PAVING PROJECT LAYOUT

SURVEYED BY	N/A	DATE	N/A
DRAWN BY	J.N.	DATE	8/98
SQUAD LEADER	T.P.K.		
DESIGN FILE NO.	/pave/96bl54/pbl54.dgn		
IPARM FILE	pbl54.i	DATE PLOTTED	N/A
PROJ. NAME	FAIR HAVEN - RUTLAND		
PROJ. NO.	NH 9727(IIS)		
SHEET	12 OF I19	SHEETS

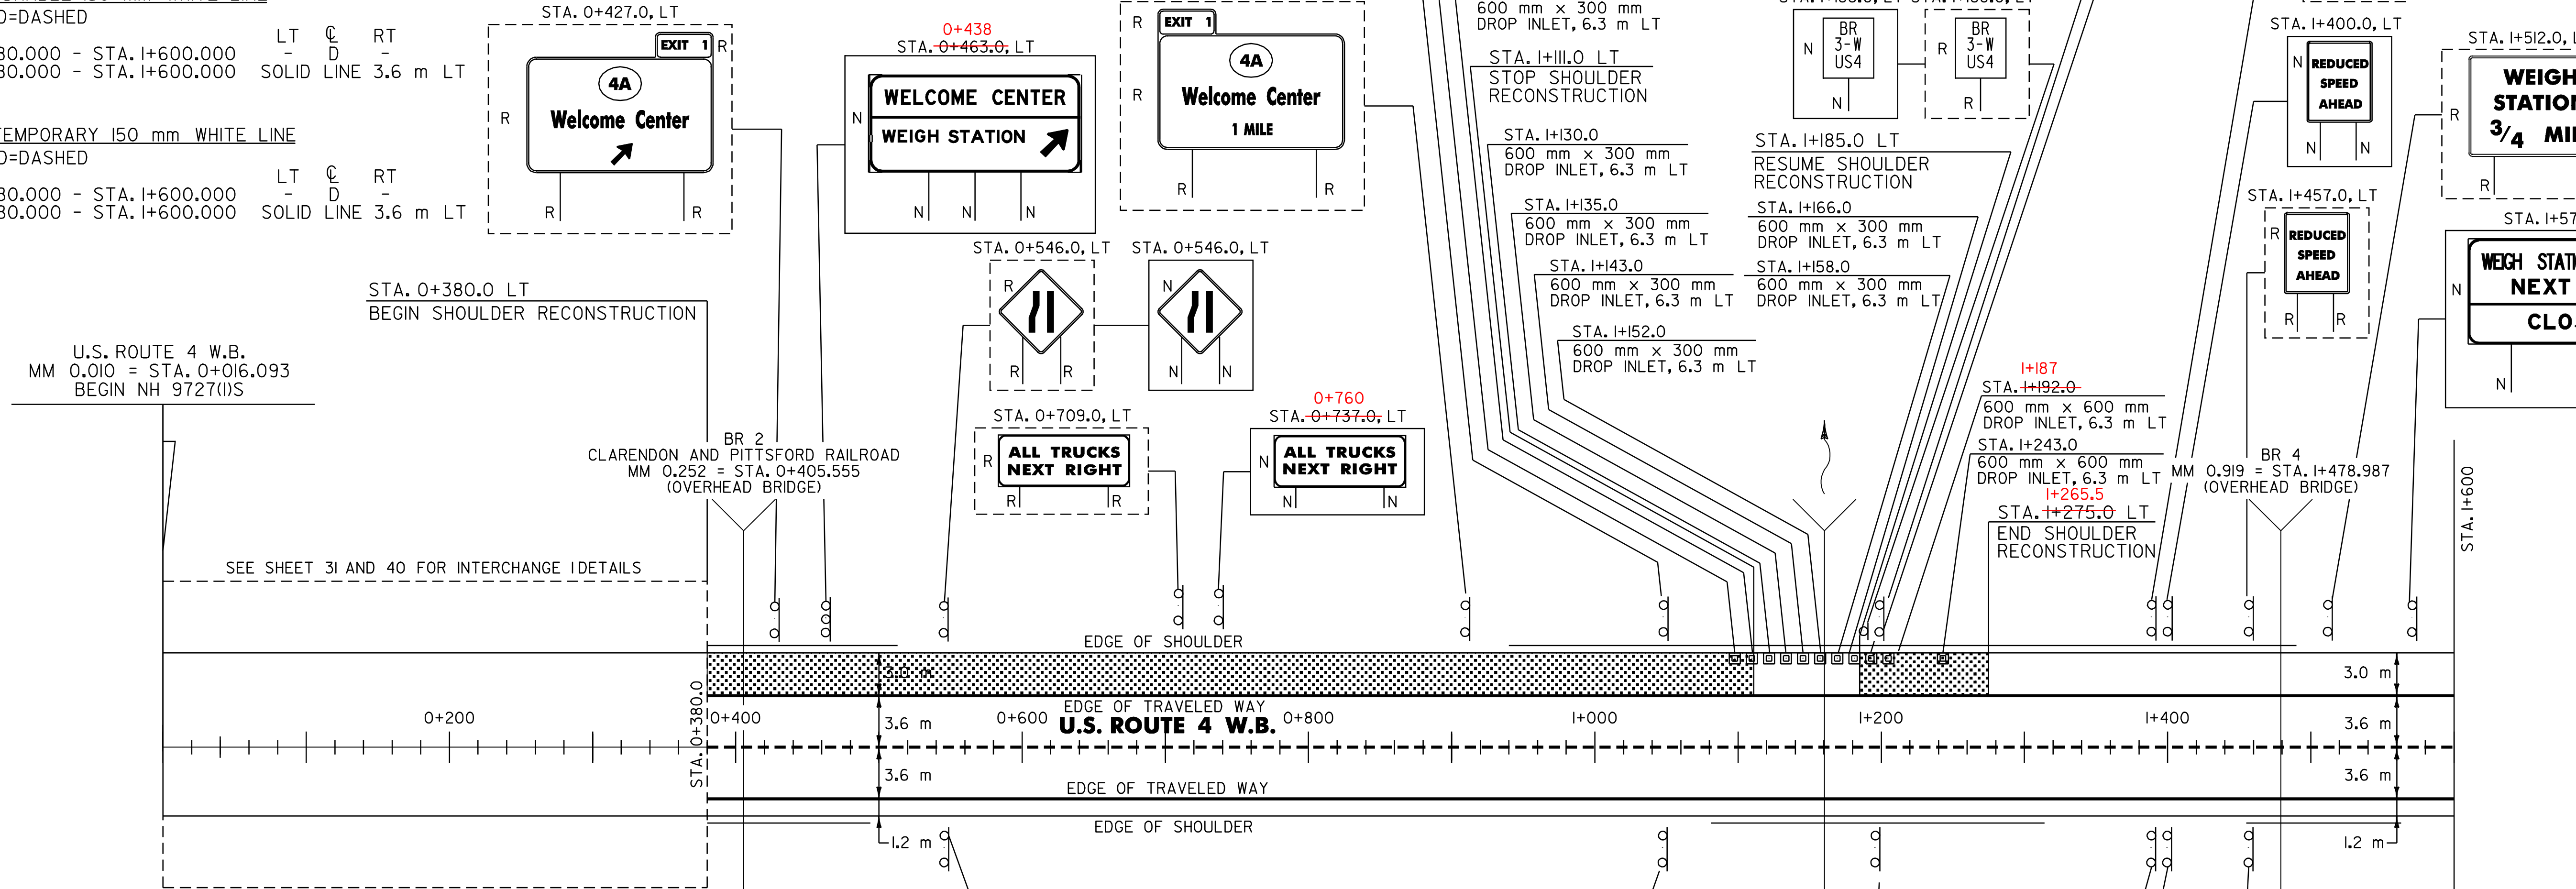
~~STA. I+105.0 LT~~
~~STA. I+123.0 LT~~
~~STA. I+130.0 LT~~
~~STA. I+135.0 LT~~
~~STA. I+143.0 LT~~
~~STA. I+152.0 LT~~
~~STA. I+158.0 LT~~
~~STA. I+166.0 LT~~
~~STA. I+174.0 LT~~
~~STA. I+192.0 LT~~
~~STA. I+243.0 LT~~

DID NOT CHANGE ELEVATIONS ON BRIDGE DECK (10 EACH)

621.60 ANCHOR FOR STEEL BEAM RAIL
 STA. 0+949.2 LT 927.7
 STA. 0+672.1 LT

621.74 ALUMINUM APPROACH RAILING
 STA. I+097.4 - STA. I+105.0 LT (7.6 m)
 092.3 099.9

616.35 TREATED TIMBER CURB
 STA. I+035.0 - STA. I+105.0 LT (70.0 m)
 069.0 099.0

621.20 STEEL BEAM GUARDRAIL
 STA. 0+948.6 - STA. I+097.4 LT (148.8 m)
 0+932.1 I+092.3

621.54 MODIFIED ECCENTRIC LOADER TERMINAL
 STA. I+555.4 - STA. I+566.8 RT
 I+542.6 I+554.0

621.80 REMOVAL AND DISPOSAL OF GUARDRAIL
 0+934 STA. 0+949.0 - STA. I+105.0 LT (156.0 m) I+099 (165 m)
 STA. I+555.4 - STA. I+563.0 RT (7.6 m)
